Product/Process Change Notification (PCN)

Customer: Newark

Date: August 21, 2015

This notification encompasses both a wafer, package and brand enhancement to the subject devices.

Package Body Overlay

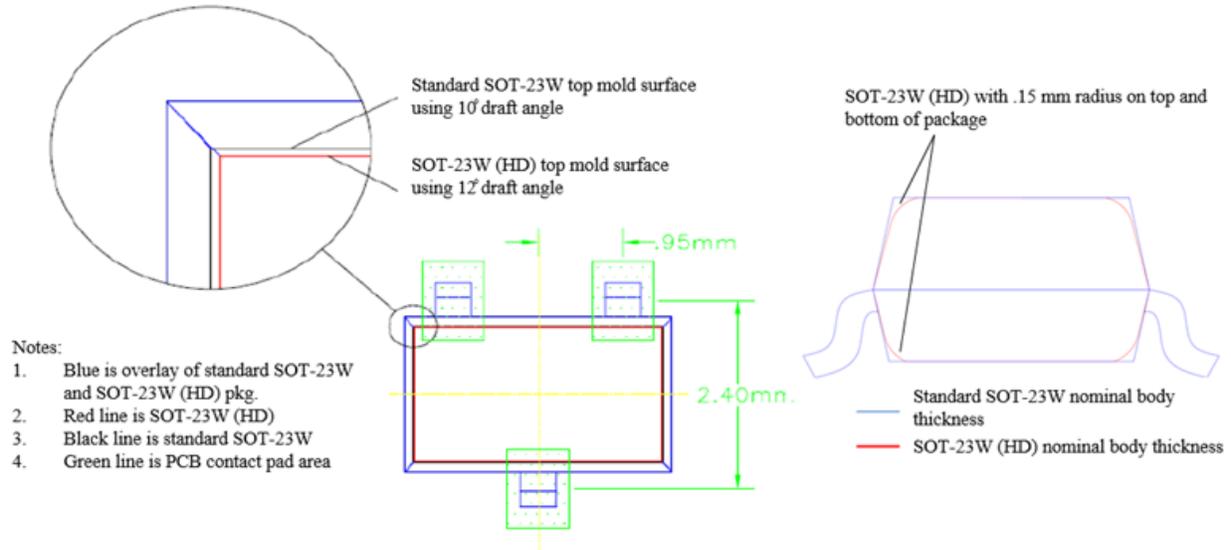
Standard SOT23W vs. SOT-23W (HD)

Standard SOT-23W	SOT-23W (HD)
	Nominal	Nominal
Radii	NA	0.15
Draft angle	10°	12°

Top Brand Comparison	
From: Standard SOT-23W	To: SOT-23W (HD)
01E	101

- **Standard SOT-23W Brand:**
Last two digits of part number + Temperature range designator
- **SOT-23W (HD) Brand:**
Last three digits of the part number
